Re: EAR RSW Airport Layout Plan Update

**Southwest Florida International Airport  
Airport Layout Plan Update**

**AIRPORT LAYOUT PLAN UPDATE  
SUMMARY REPORT  
SOUTHWEST FLORIDA INTERNATIONAL AIRPORT (RSW)**

RE: Southwest Florida International Airport (RSW;) Ft. Myers, Florida  
Conditional Airport Layout Plan Approval

**AIRPORT LAYOUT PLAN**

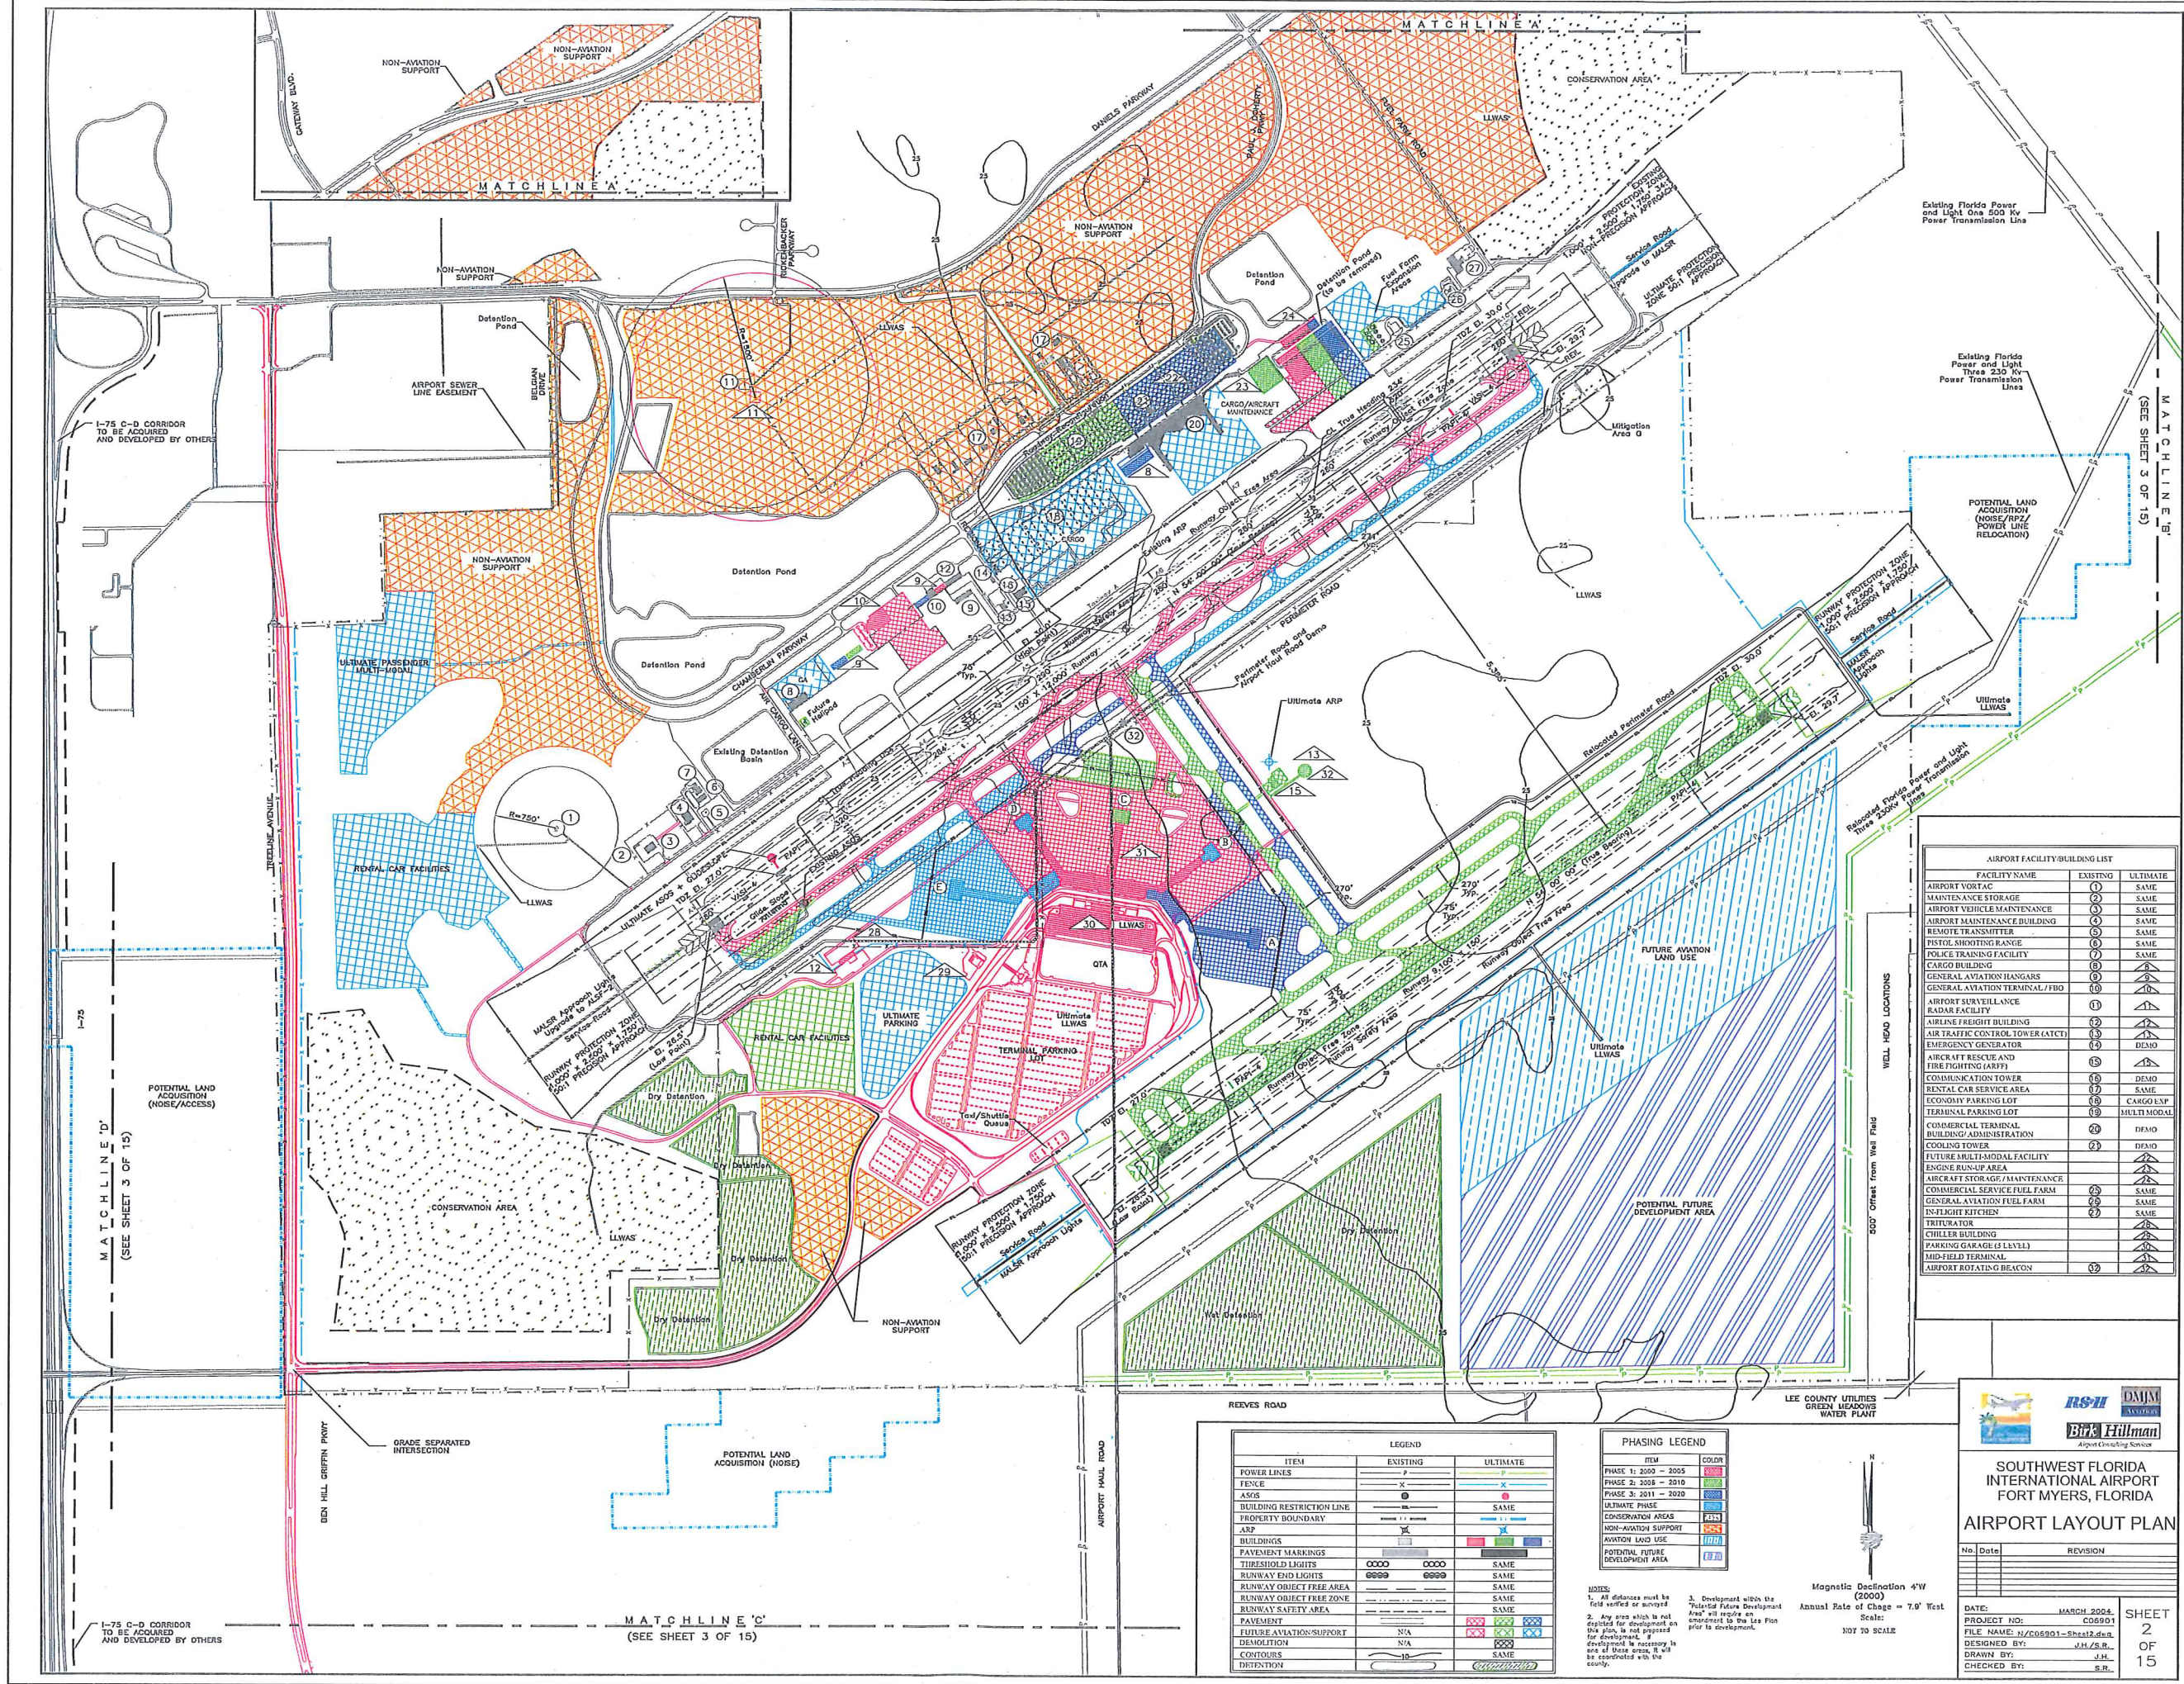
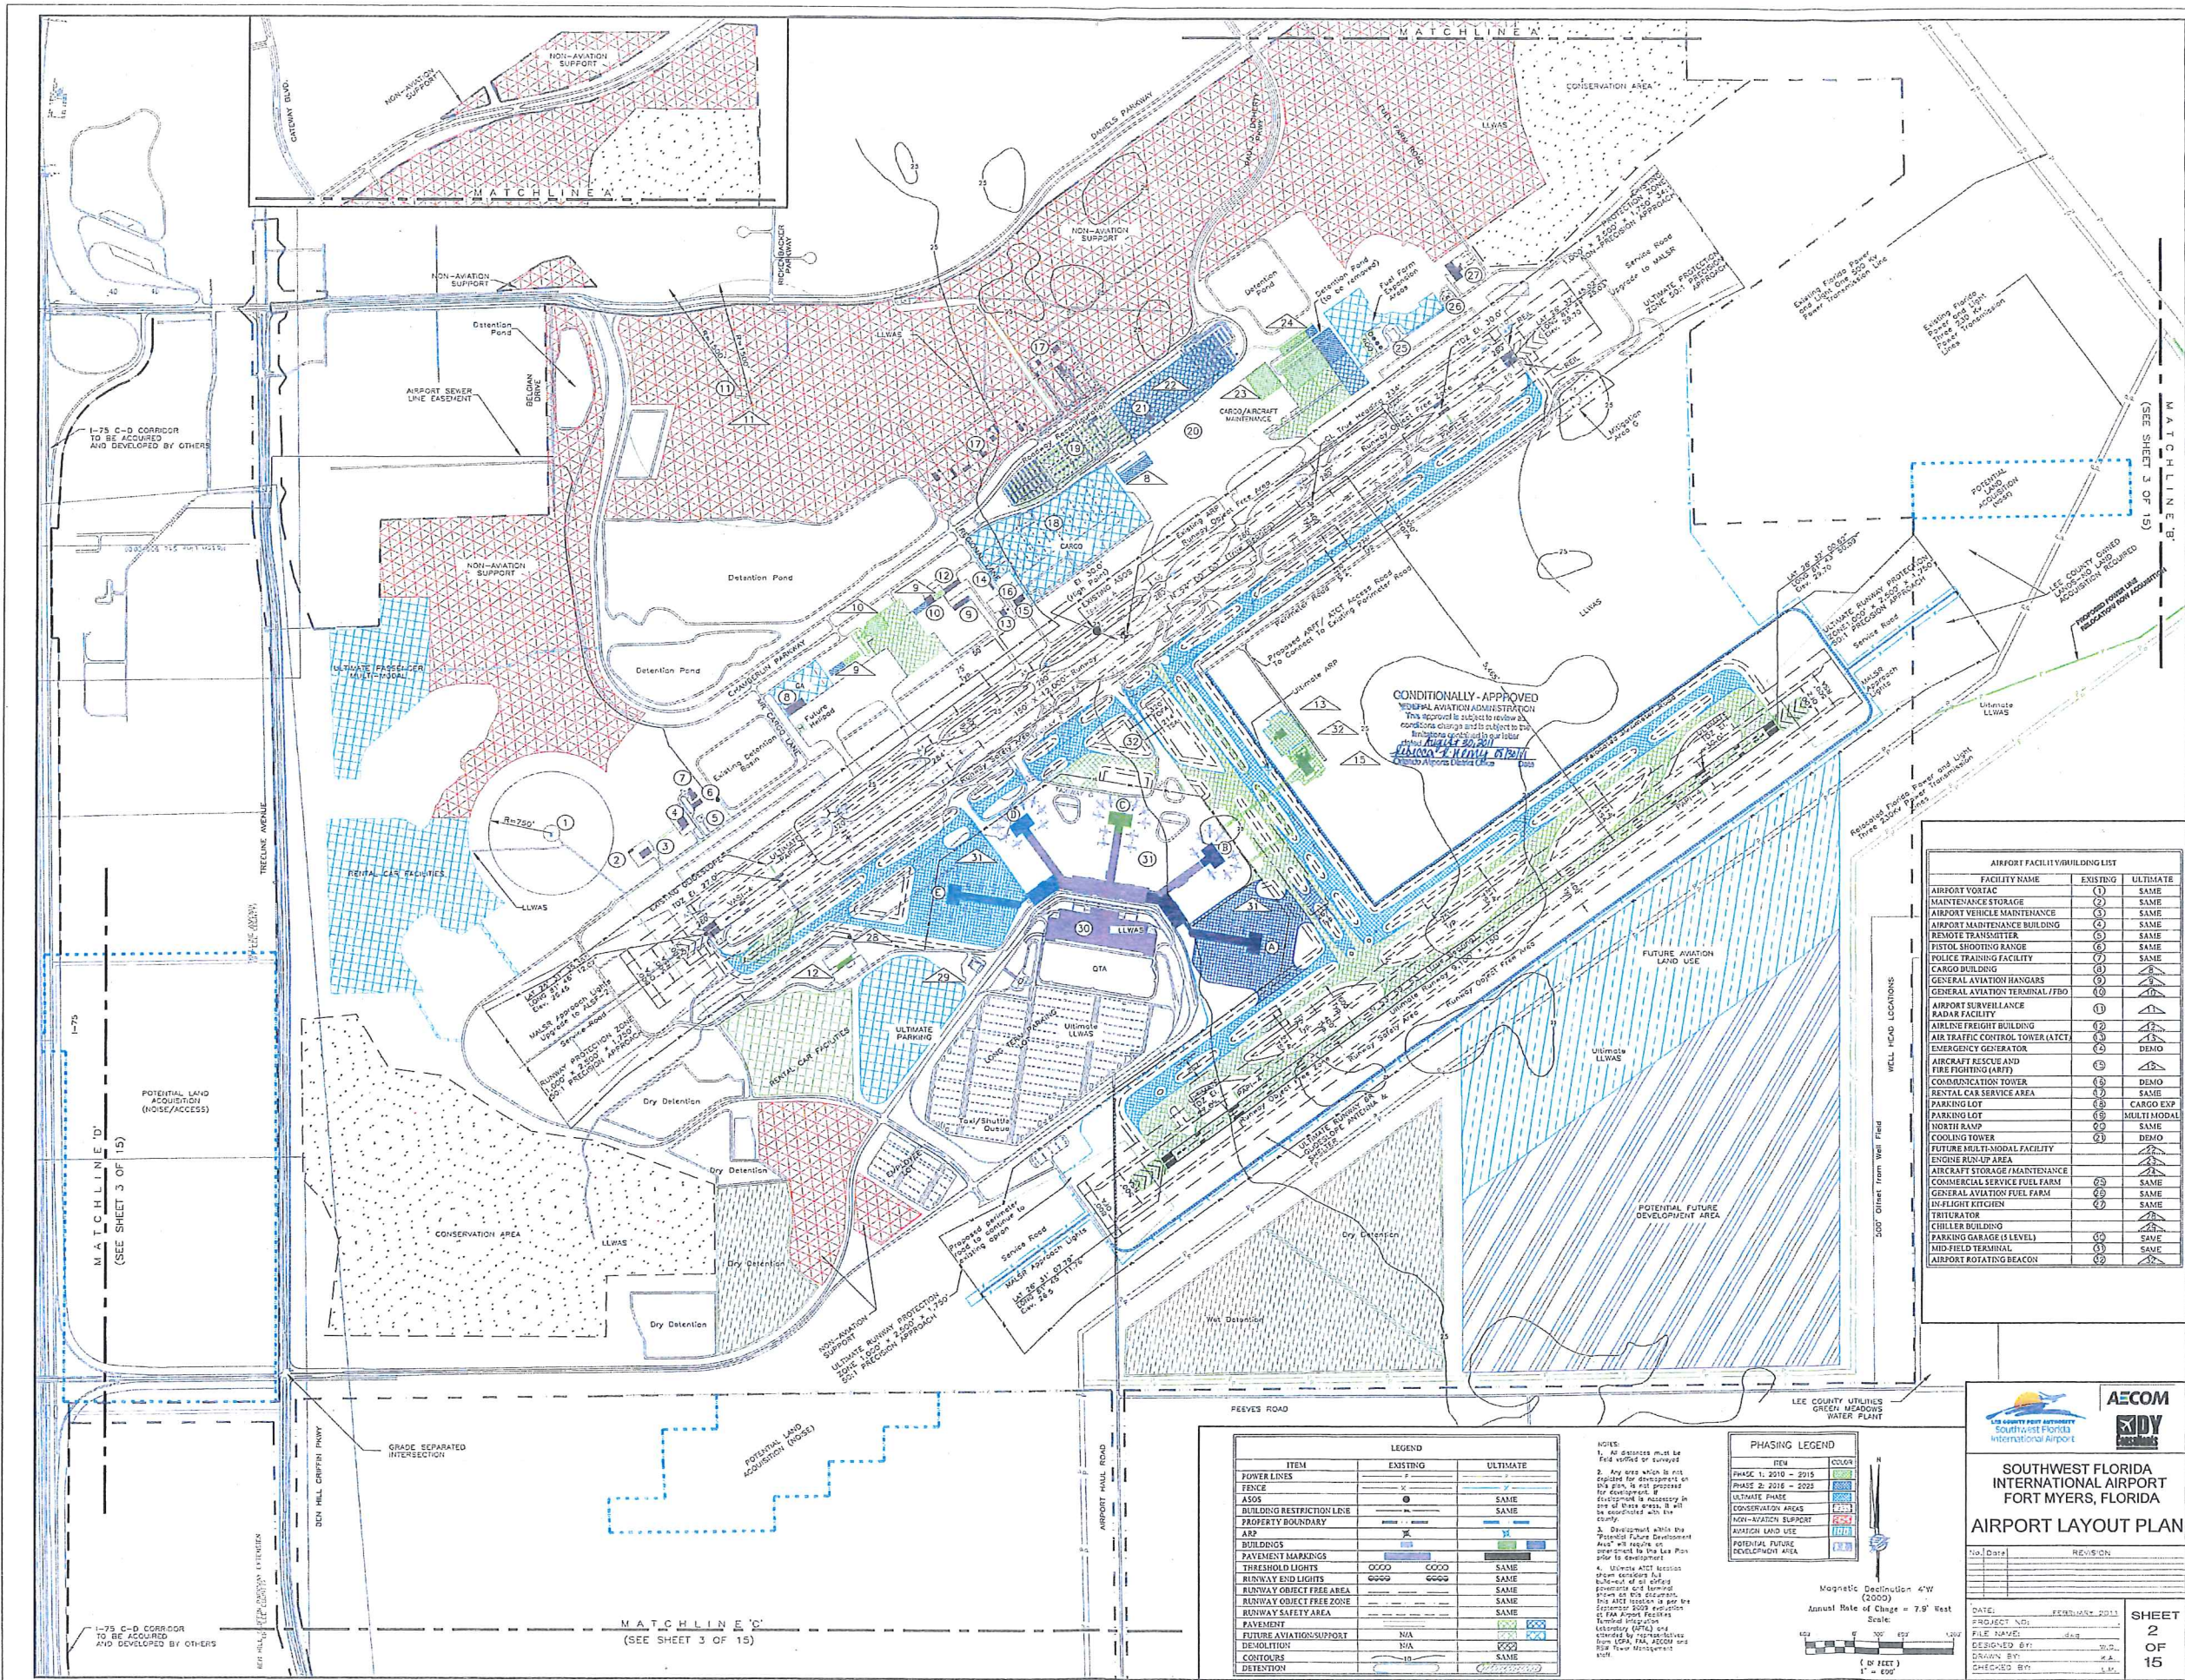
The proposed runway configuration depicted in this 2009 ALP Update requires an 80-foot shift to the south to increase the runway to runway centerline separation from the location shown on the 2004

ALP. This shift provides RSW with an unconstrained Group V runway and parallel taxiway and full dual parallel taxiway that will meet all foreseeable future and ultimate Group V aircraft demands as well as double-back aircraft taxiing operations as recommended by the FAA. The layout also provides sufficient space for necessary blast deflector fencing, and a perimeter road around the proposed runway and taxiway system to the midfield terminal apron. The 80-foot shift also provides ample area for future Concourse A terminal development.

The location of the ATCT in this ALP Update differs slightly from the location depicted on the 2004 ALP. It is now north of the ARFF facility. An extensive ATCT Line of Sight Analysis and a September 2009 evaluation by the FAA Airport Facilities Terminal Integration Laboratories (AFTIL) resulted in this preferred location now shown on the 2009 ALP Update. In attendance at the September 2009 AFTIL

- New Runway 6R-24L configuration;
- Midfield Taxiways and Apron layout
- New ARFF Station site layout
- New ATCT development area
- Existing facilities shown
